## Responses to Stakeholder Comments on 2050 Transmission Study Final PAC Presentation and Report

ISO New England gave a final presentation to the Planning Advisory Committee (PAC) on the 2050 Transmission Study on October 18, 2023, and released a draft 2050 Transmission Study Report for stakeholder review and comment on November 1, 2023. A draft Technical Appendix to the 2050 Transmission Study Report was subsequently released on December 4, 2023.<sup>1</sup> In response to these documents, written feedback was received from several stakeholders. The following stakeholders provided written feedback:

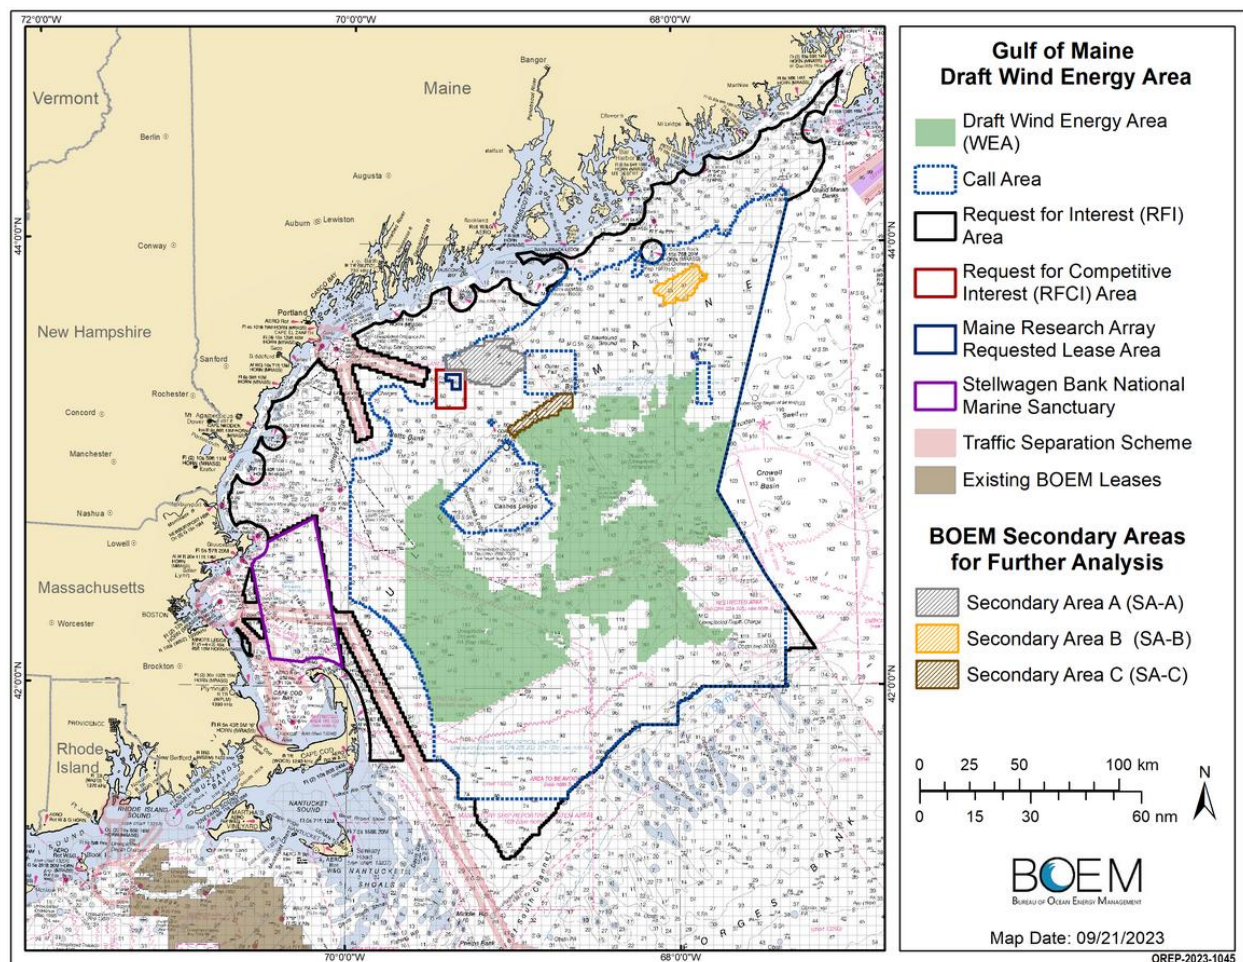
Relocating a large share of floating wind POIs from NH and ME to South of the Boston Import interface is reasonable in light of the above, and to reflect the location of proposed lease areas in the Gulf of Maine. As shown in the map below from the Bureau of Ocean Energy Management,<sup>7</sup> the proposed Gulf of Maine lease areas are roughly equidistant from MA and ME:

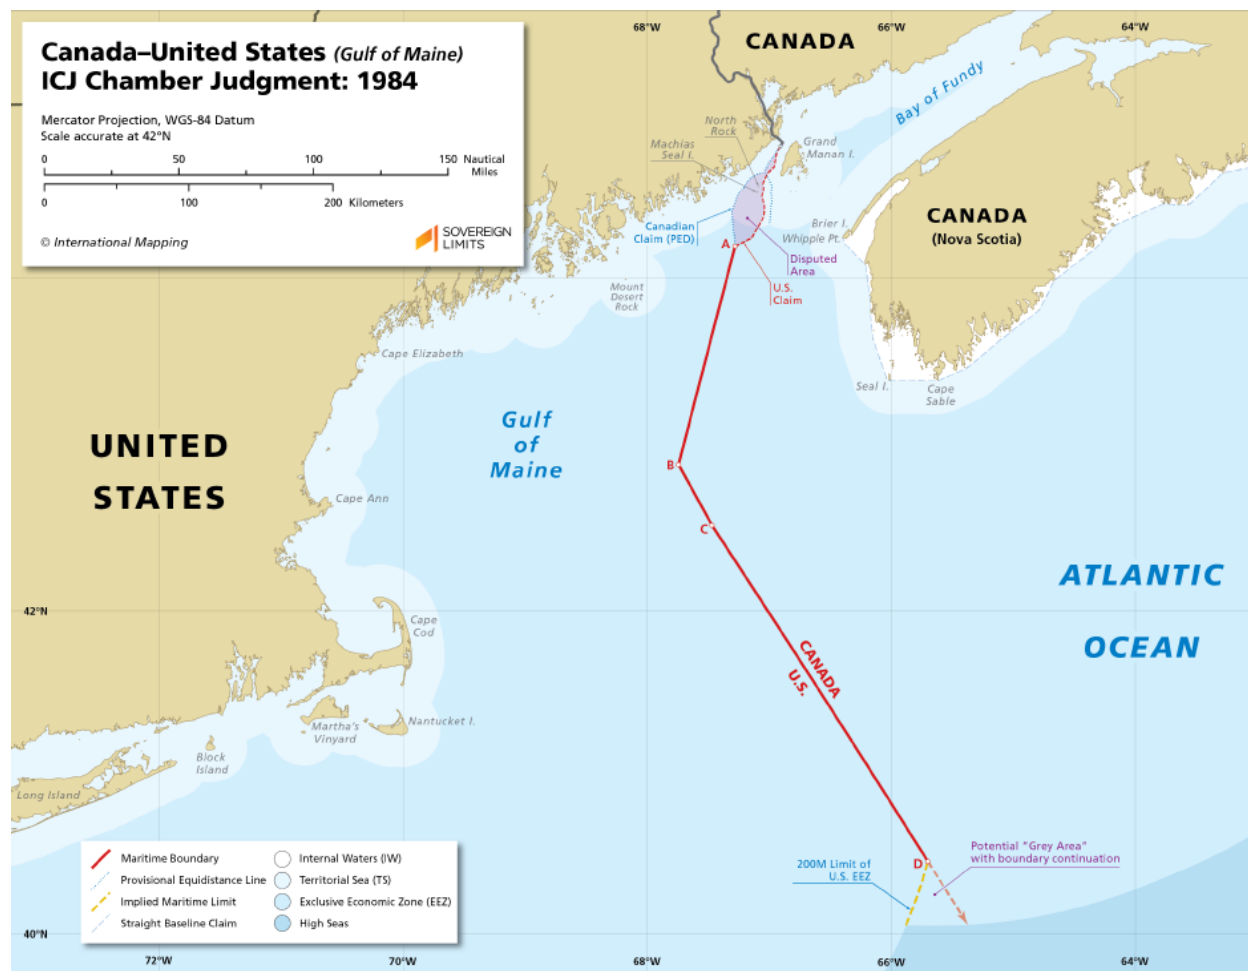
To evaluate the benefits of more strategic offshore wind injections, in targeted or future analyses, ISO-NE could evaluate scenarios that rebalance injection of fixed bottom offshore wind to CT and that rebalance injection of floating wind to MA. In such a sensitivity and all modeling of offshore wind injections going forward, ISO-NE should assume 1,200 MW or 2,000 MW injections to match injection capabilities of 320 kV and 525 kV HVDC voltage systems, respectively, which have become industry standards.

Specifically, a sensitivity for fixed bottom wind could include:

- 1,200MW into Southwest Connecticut (Bridgeport) in 2035
- 1,200MW into Southeast Connecticut (Montville) in 2035
- Additional 1,200MW into Southwest Connecticut (Bridgeport) in 2050
